# **FINAL DRAINAGE REPORT**

## **LARGENT SUBDIVISION 6985 MERIDIAN ROAD**

January 18, 2018  
Revised April 18, 2018  
Revised May 14, 2018

**JPS Project No. 091701  
PCD Project No. SF-18-003**

## DETENTION BASIN STAGE-STORAGE TABLE BUILDER

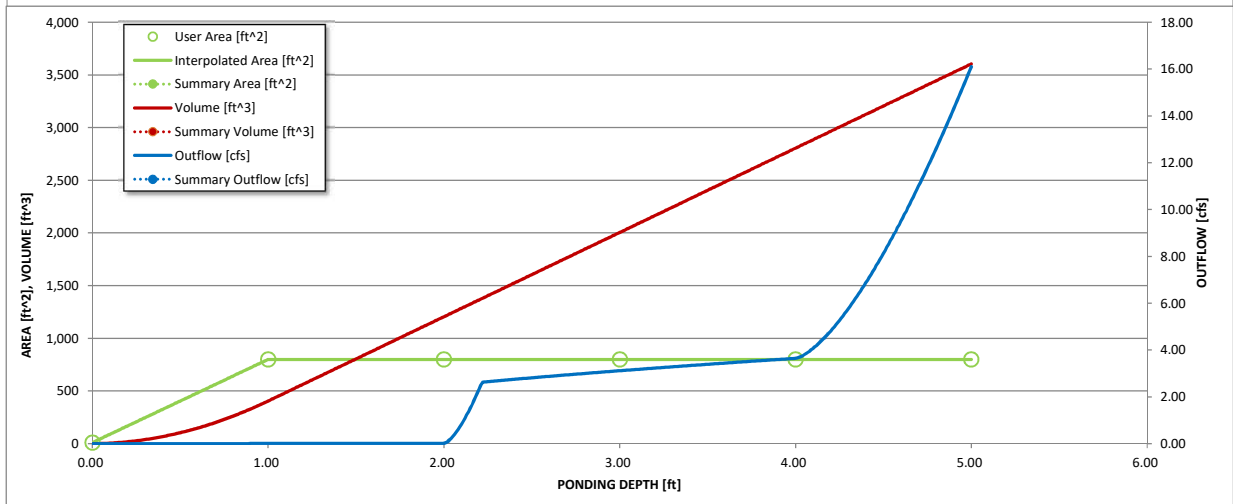
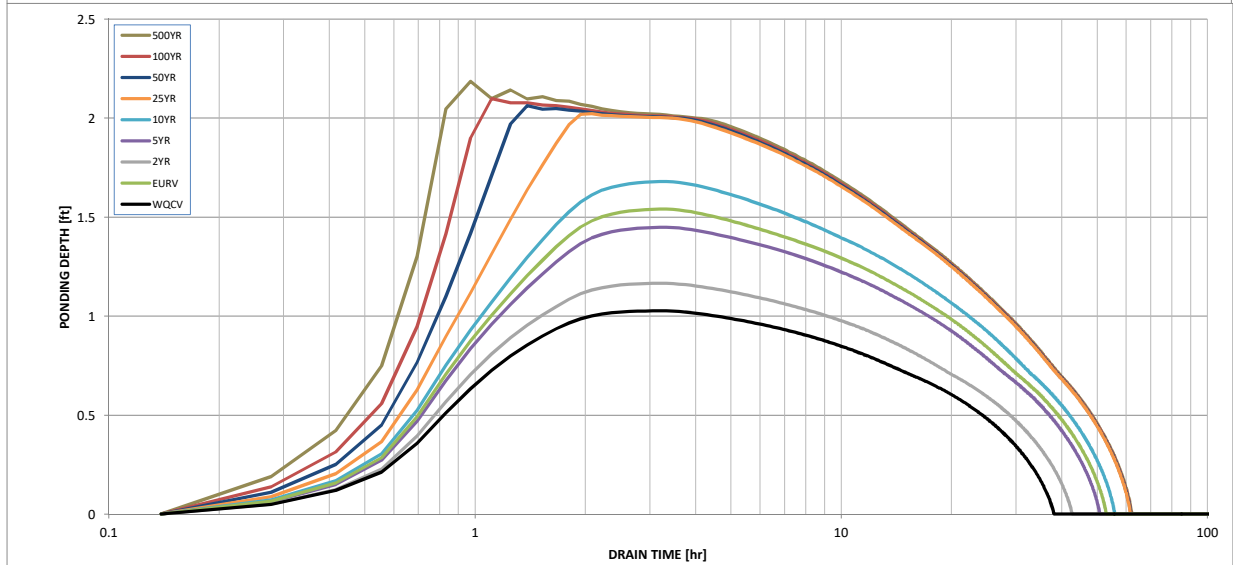
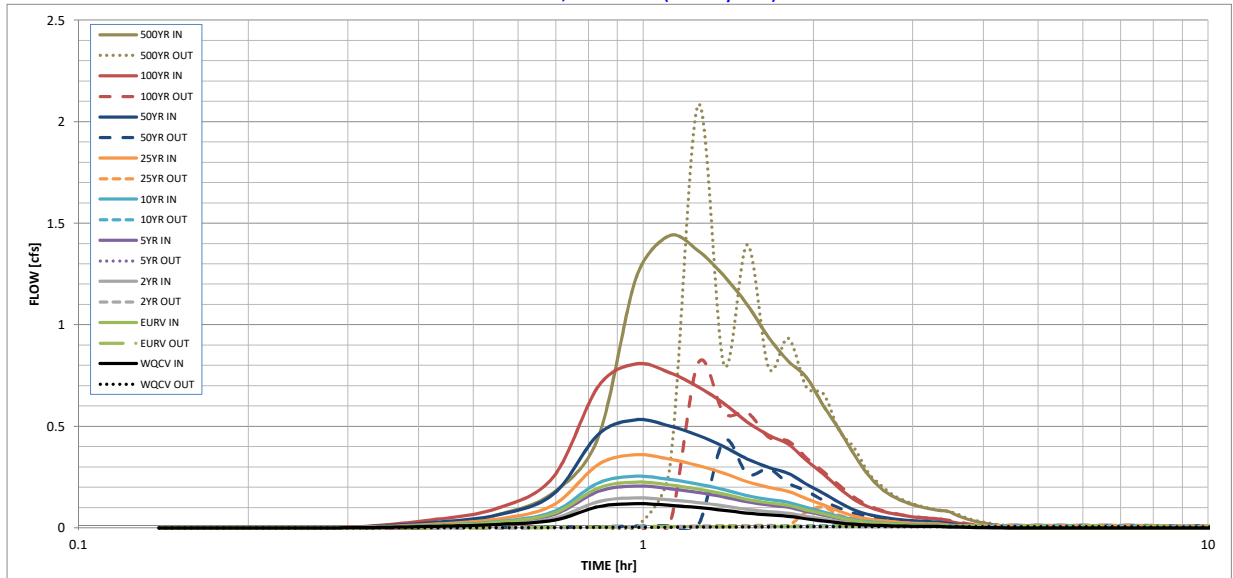
Revise to the developed percent impervious of the tributary watershed (sub-basin A1). Update the pond design and narrative accordingly.
